## **LIFETOUCH SUBDIVISION**

APPLICATION NUMBER 13 DATE April 15, 2004

REQUEST Subdivision

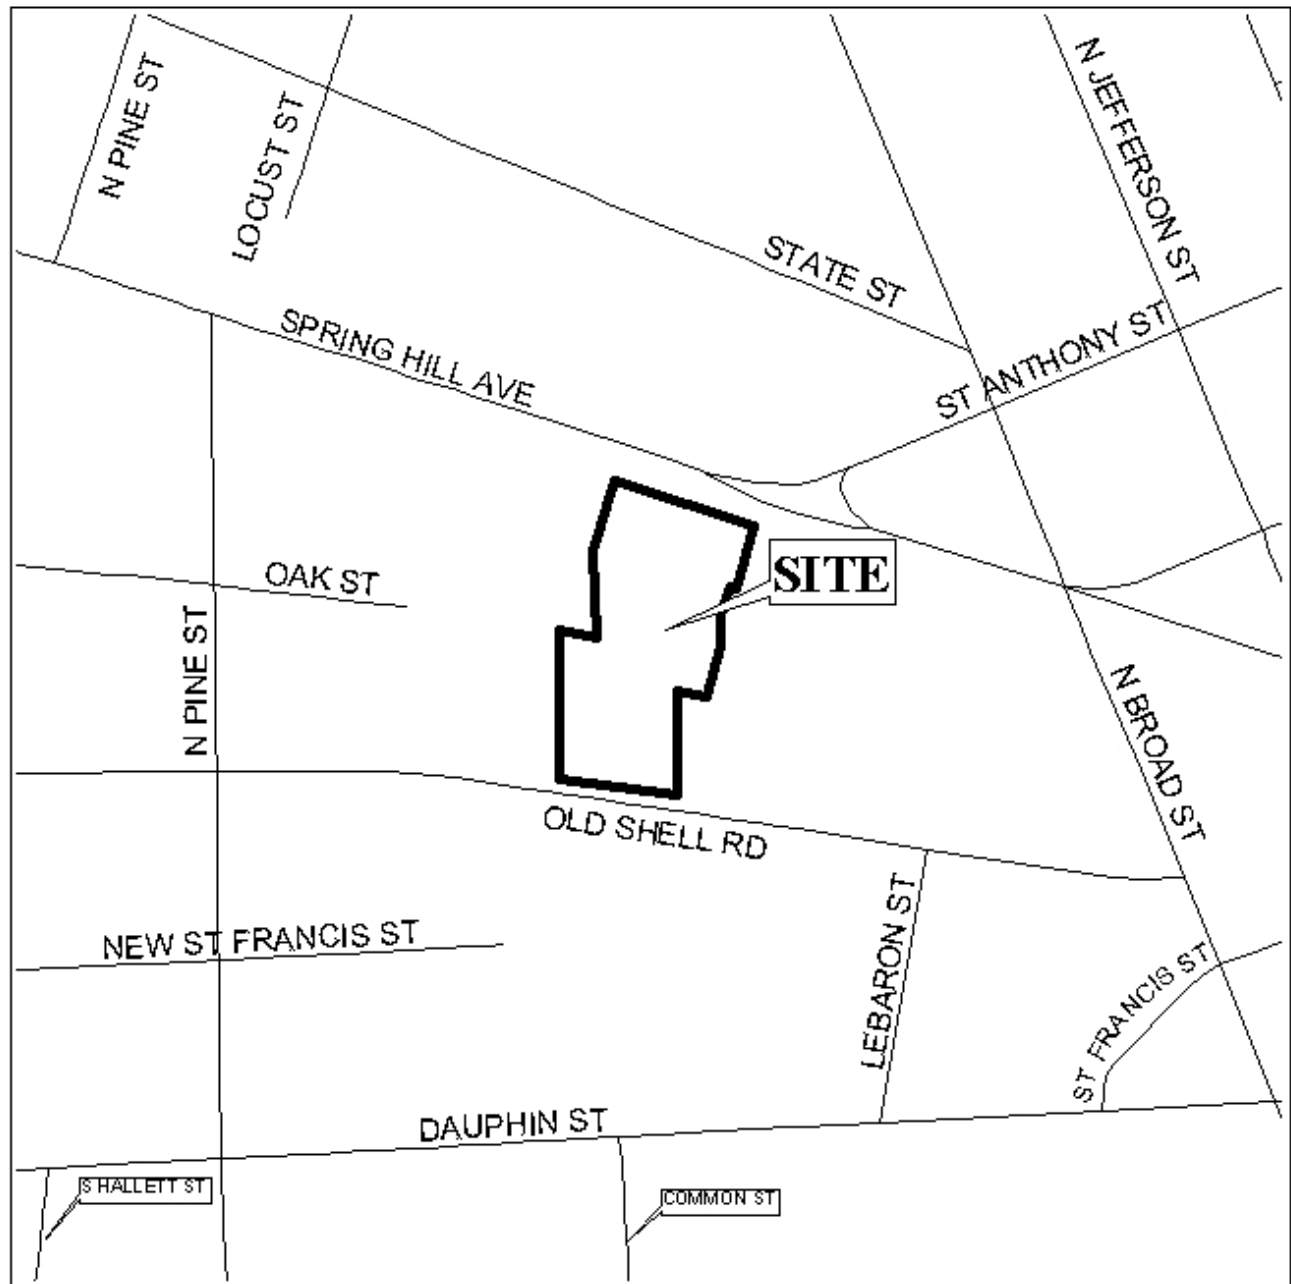
The plat illustrates the proposed 1 lot, 1.9  $\pm$  acres subdivision which is located on the South side of Springhill Avenue, 430'  $\pm$  West of Broad Street, extending to the North side of Old Shell Road, 630'  $\pm$  West of Broad Street and is in City Council District 2. The subdivision is served by public water and sanitary sewer.

The site fronts Springhill Avenue, a planned major street as illustrated on the Major Street Plan and has an existing right-of-way in compliance with the Plan. However, as a means of access management, the placement of a note on the final plat stating that the site is limited to one curb cut to Springhill Avenue and one curb cut to Old Shell Road, with the location, size, and design to be approved by Traffic Engineering, should be required

The purpose of this application is to combine six lots into one lot of record. As illustrated by the vicinity map, if approved, the lot would be split zoned B-4 and R-1. The Commission has consistently not approved subdivisions that would create a split-zoned property. In this instance, rezoning of the R-1 portion of the site to B-4 is highly unlikely. A more appropriate option would be a two-lot subdivision – one lot consisting of the B-4 properties and the other consisting of the R-1 properties.

As a portion of the site is zoned B-4, which allows 0' setbacks and 100% site coverage, the required 25' setback would not be appropriate. Therefore, the 25-foot minimum building setback line should only be required for the Old Shell Road frontage.

Based on the preceding, it is recommended that the plat be modified to a two lot subdivision - one lot consisting of the B-4 properties and the other consisting of the R-1 properties – and be granted Tentative Approval, subject to the following conditions: 1) the placement of a note on the final plat stating that the site is limited to one curb cut to Springhill Avenue and one curb cut to Old Shell Road, with the location, size, and design to be approved by Traffic Engineering; and 2) the placement of the 25-foot minimum setback line from Old Shell Road on the final plat (no setback required from Spring Hill Avenue).
